STATE OF CONNECTICUT  
CONNECTICUT SITING COUNCIL

IN RE: :  
: :  
APPLICATION OF CELLCO PARTNERSHIP : DOCKET NO. 360  
D/B/A VERIZON WIRELESS FOR A :  
CERTIFICATE OF ENVIRONMENTAL :  
COMPATIBILITY AND PUBLIC NEED FOR :  
THE CONSTRUCTION, MAINTENANCE :  
AND OPERATION OF A WIRELESS :  
TELECOMMUNICATIONS FACILITY ON :  
PROPERTY OF THE FALLS VILLAGE :  
VOLUNTEER FIRE DEPARTMENT, INC., :  
188 ROUTE 7 SOUTH, FALLS VILLAGE, :  
CONNECTICUT : JUNE 16, 2008

RESPONSES OF CELLCO PARTNERSHIP D/B/A VERIZON WIRELESS  
TO CONNECTICUT SITING COUNCIL PRE-HEARING INTERROGATORIES

Docket No. 360  
 Response to Connecticut Siting Council Pre-Hearing Interrogatories  
 Question 20  
 Existing Verizon Wireless PCS Coverage With  
 Proposed Facility At 130 Feet AGL  
 (\* Map Scale is 1:30,000)

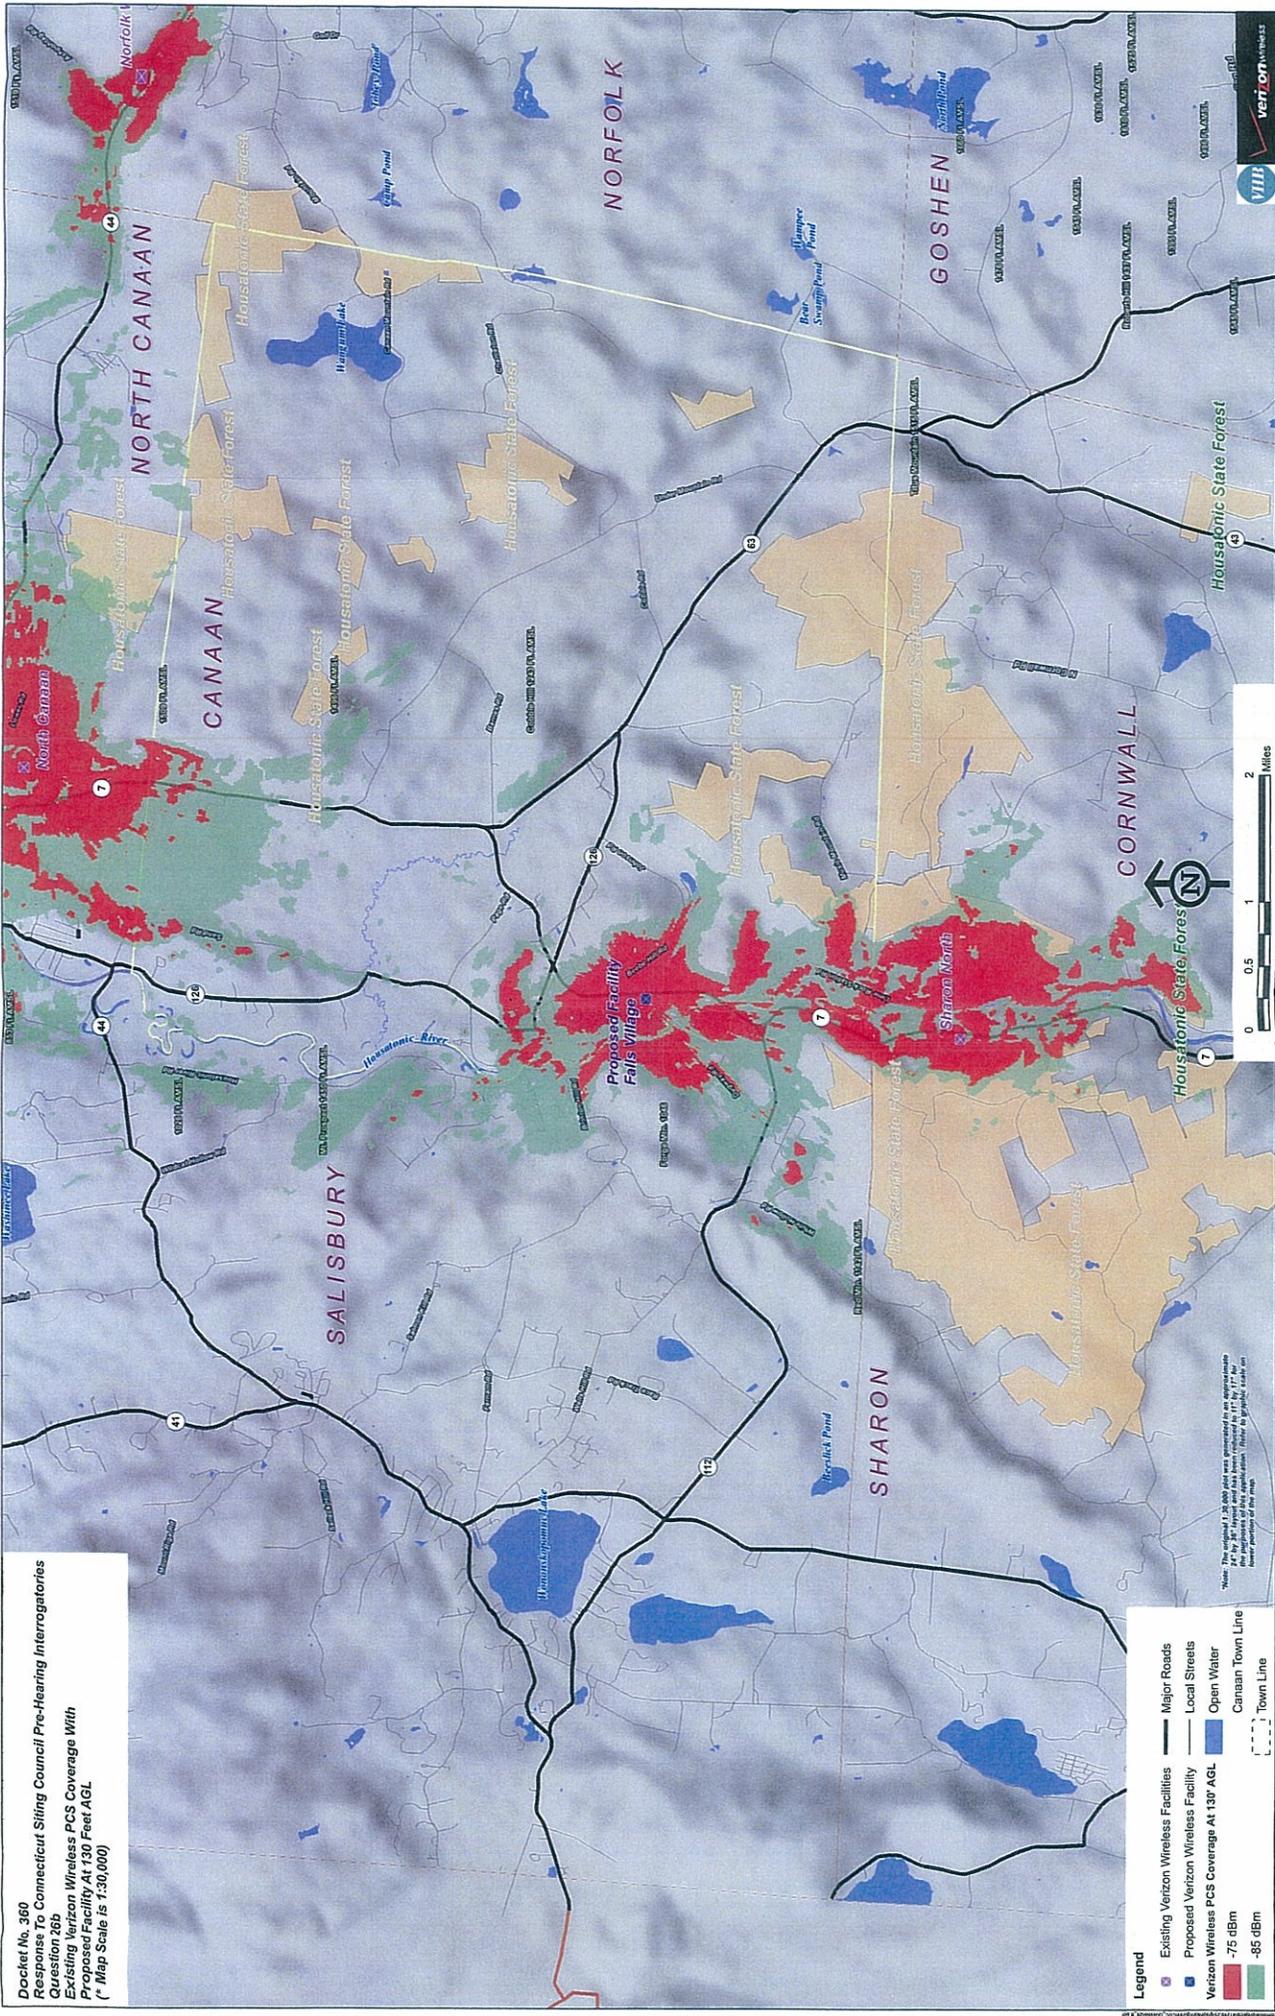
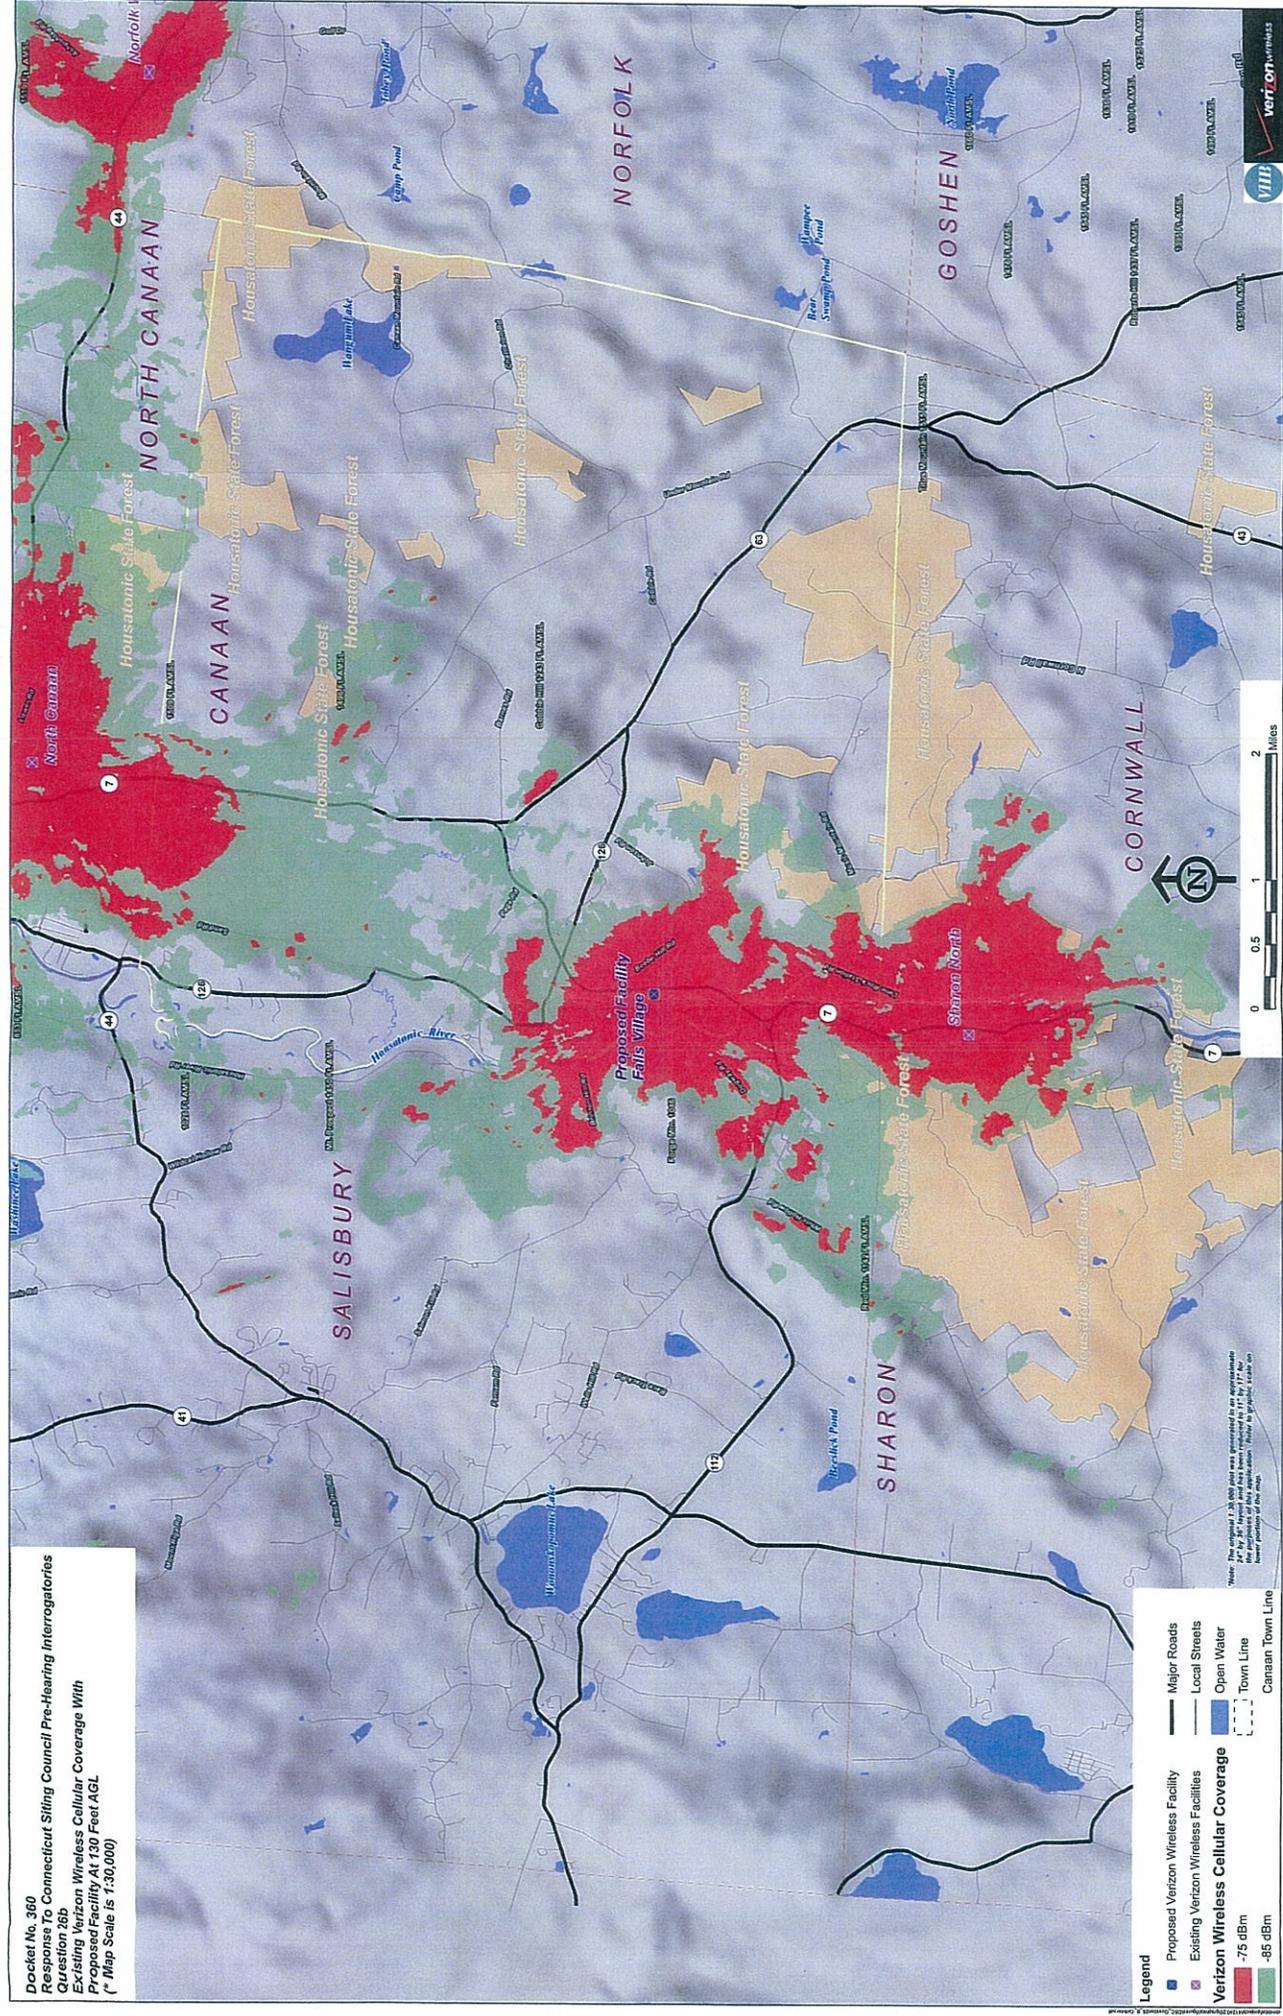
Provide a multi-signal level propagation plot (including the signal levels Cellco designs for), at a scale of 1:30,000, depicting coverage from the following:

- a) existing sites and proposed site at an antenna height of 140 feet above ground level.
- b) existing sites and proposed site at an antenna height of 130 feet above ground level.

As discussed above, Cellco has recently acquired and expects to deploy both PCS and cellular service at the proposed Falls Village Facility. Included behind Tab 2 of these responses are coverage plots depicting coverage from the proposed Falls Village Facility at the heights requested at both PCS and cellular frequencies.
